# INTERNATIONAL CODE COUNCIL

## 2009/2010 CODE DEVELOPMENT CYCLE

### PROPOSED CHANGES TO THE 2009 EDITIONS OF THE

**October 24 2009 – November 11, 2009**

**FIGURE 308.6(1)**  
**REDUCED CLEARANCE DIAGRAM**

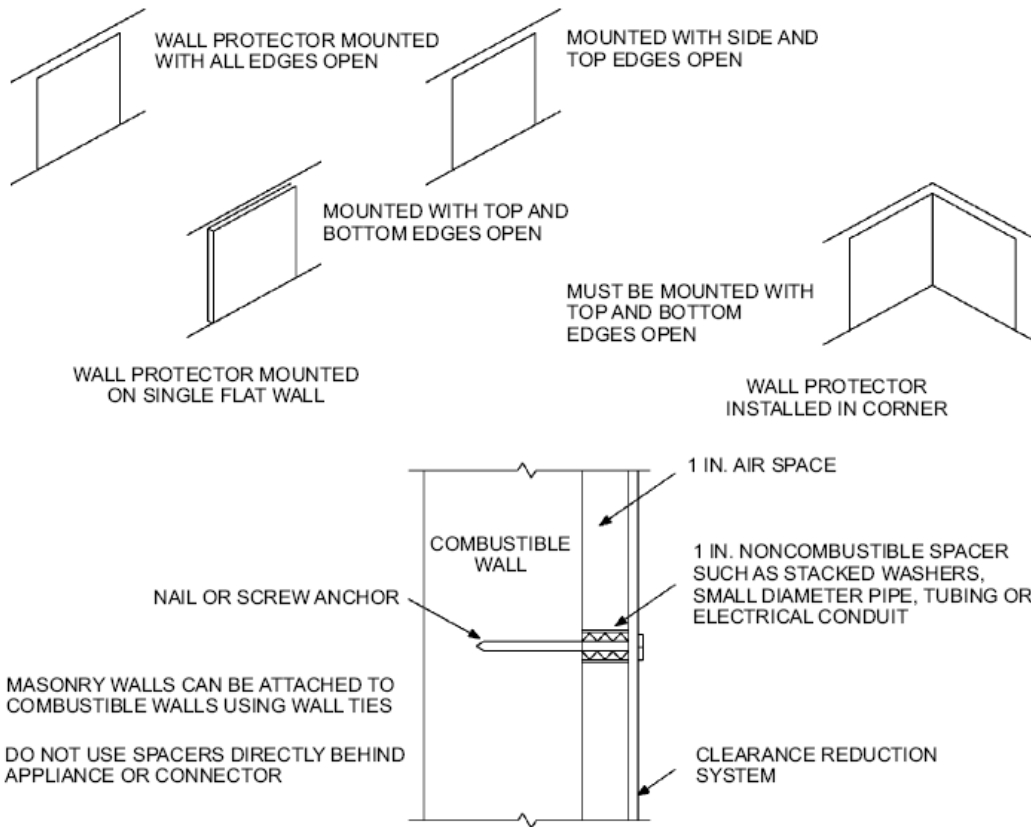
**2. Add new figures as follows:**

NOTE: "A" equals the required clearance with no protection. "B" equals the reduced clearance permitted in accordance with Table M1306.2. The protection applied to the construction using combustible material shall extend far enough in each direction to make "C" equal to "A."
